September 11, 2018
L-18-188

SUBJECT:
Davis-Besse Nuclear Power Station, Unit No. 1
Docket No. 50-346, License No. NPF-3
Response to Request for Additional Information and Supplemental Information
Regarding License Amendment Request to Adopt National Fire Protection Association
(NFPA) Standard 805 (CAC No. MF7190, EPID L-2015-LLF-0001)

Response to RAI
Page 1 of 12

Figure 1 – General Form of MCR Abandonment Scenario Logic

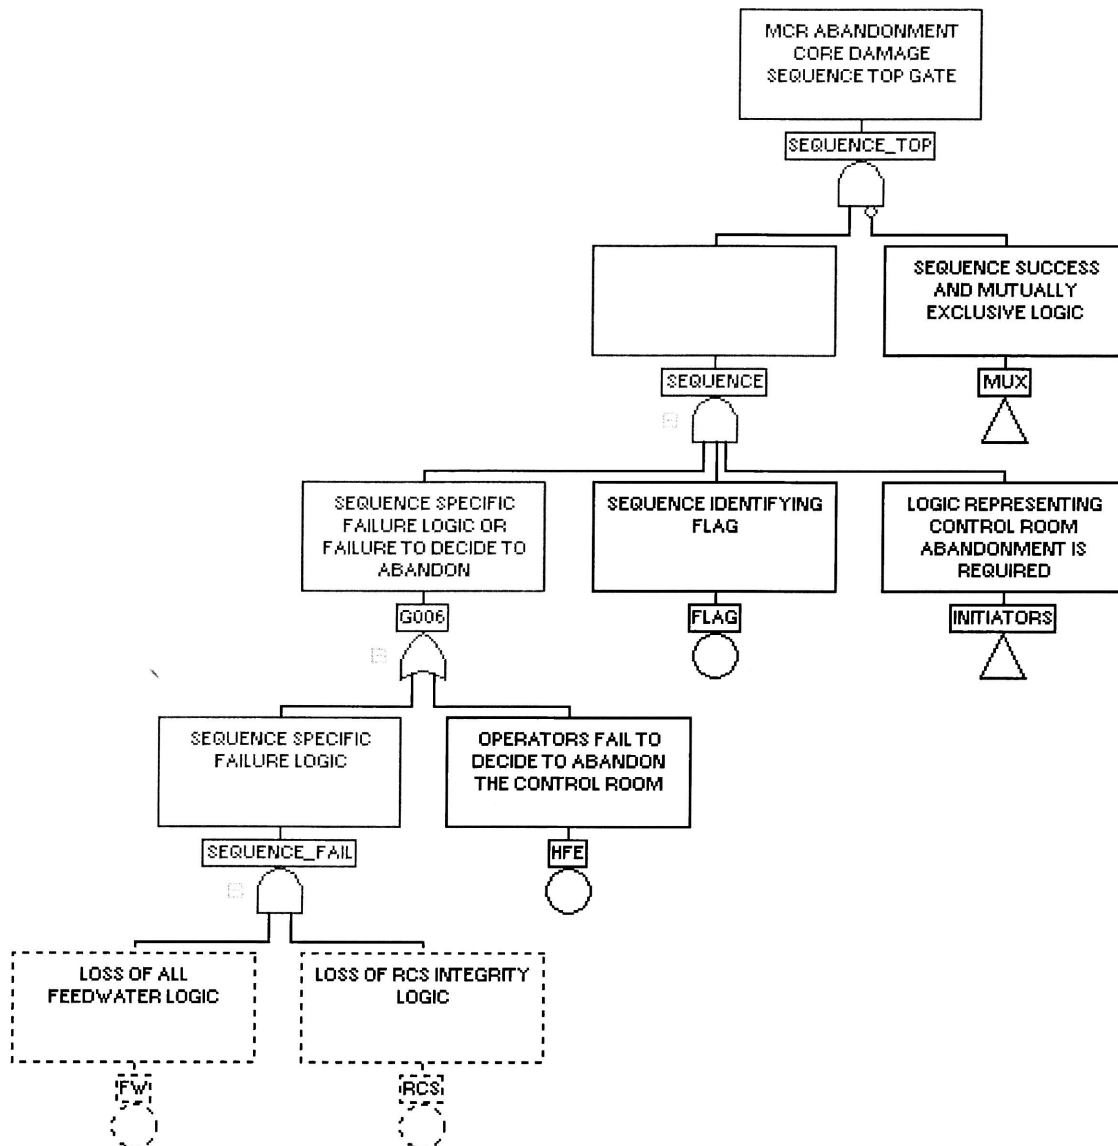
- b) One of the simplifying assumptions in the modeling of MCR abandonment scenarios is that if abandonment is required, and operators fail to decide to do so, core damage occurs. From a CDF modeling standpoint, it does not matter if the cognitive human failure event (HFE) is assigned to all or just one of the core damage sequences, since the results will subsume to a single set of cutsets. Figure 1 illustrates this relationship. This represents the general form of the MCR abandonment modeling for all sequences. The 'INITIATORS' logic is identical for all of the MCR abandonment scenarios. The 'FLAG' event is specific to each scenario, but it is ignored by the software when subsuming cutsets. In the RAI 03 model, only the TBQU sequence contained a gate equivalent to the G006 gate, the others (TBU and TQU) simply had the sequence failure logic directly under the 'SEQUENCE' gate. The TBU and TQU sequences have been modified to include the G006 gate equivalent for the response to this RAI. The 'SEQUENCE_FAIL' logic is either loss of all feedwater (TBU), loss of RCS integrity (TQU) or both loss of all feedwater and loss of RCS integrity (TBQU). Along with general mutually exclusive events, the sequence-specific success logic represented by the 'MUX' logic contains loss of RCS integrity logic (TBU) or loss of all feedwater logic (TQU). If the HFE event is taken to be failed, all three of the sequences reduce to {HFE, FLAG, INITIATORS} as the solution to SEQUENCE. FLAG is ignored by the software when subsuming, so the solution becomes {HFE, INITIATORS}. The only difference between the sequences will be due to the success logic, which will delete cutsets that imply loss of feedwater from TQU cutsets and delete cutsets that imply loss of RCS integrity from TBU cutsets. If only CDF is being considered, TBQU adequately represents the CDF for abandonment scenarios related to the cognitive HFE for failure to abandon. However, the sequences are not equivalent with respect to LERF quantification, since RCS conditions at the time of core damage and reactor vessel breach will be different. Therefore, the TQU and TBU sequences were modified as indicated above to include the cognitive failure to abandon the control room.

As indicated in the response to part a), additional sequences were added to MCR abandonment modeling. Sequence TBP incorporates the cognitive HFE in the same manner as the sequences detailed above. The sequences involving failure of the reactor to trip (TKBP, TKBL, TKBU) do not incorporate the cognitive HFE. This is because it is assumed to not be possible to prevent core damage if the reactor fails to trip in a control room abandonment scenario. The decision to abandon the control room is therefore not relevant and is not considered in the fault tree. The three sequences are differentiated by the early failures that occur, which directs the path through the LERF trees, but a failure to trip in an abandonment scenario is assumed to lead to core damage.

Revised risk results are shown in the revised LAR Attachment W included with this submittal.
